CITY OF ALBUQUERQUE

**Re: San Antonio Storage, 6300 San Antonio NE,
Permanent Certificate of Occupancy - Approved
Engineer's Stamp dated 02-23-10, (E-18/D061)
Certification dated 12-23-10**

Re: Certification Submittal for a Permanent Building Certificate of Occupancy (C.O.)
for **San Antonio Storage**, [E-18 / D061]
6300 San Antonio NE
Engineer's Stamp Dated 01/06/11

**San Antonio Storage
Lot 1A- P&J Subdivision
Albuquerque, New Mexico**

Concrete Channel Entrance

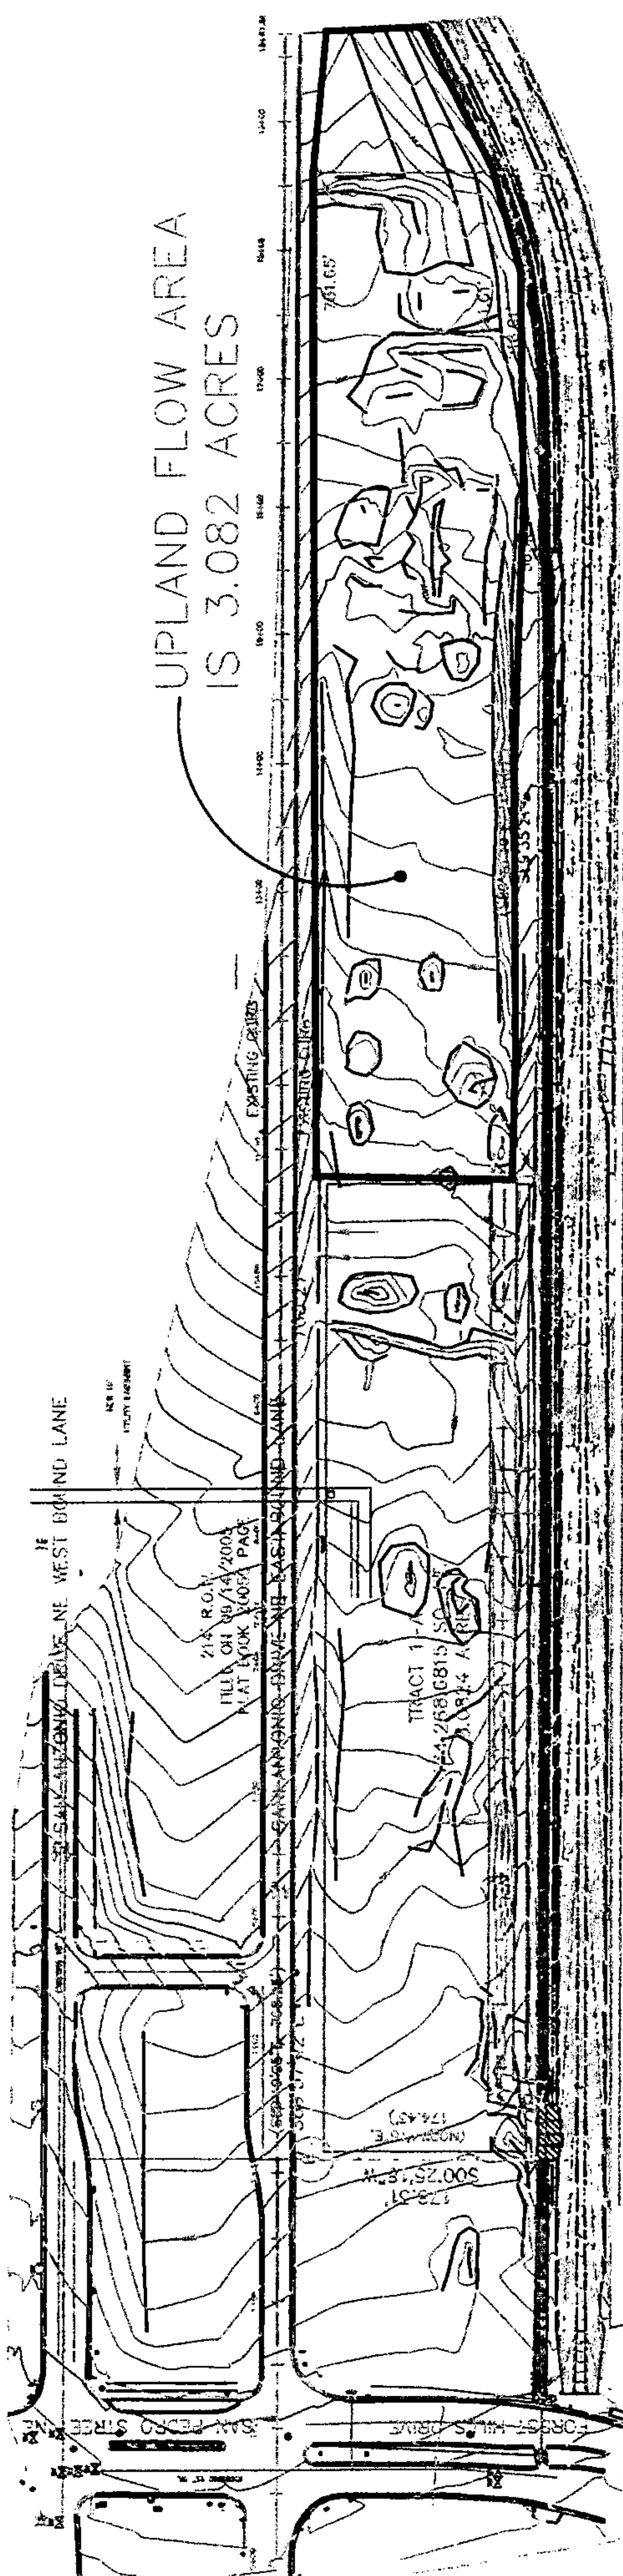
2.7

~~L = 12.52 ft~~ 12.42 13.57 (2.7)

Weir opening is 18' so OK OK

Weir opening is 10' so OK — plan has 4'

27.76

$$6.3 \sqrt{25.76}$$

4.1 cfs/ac
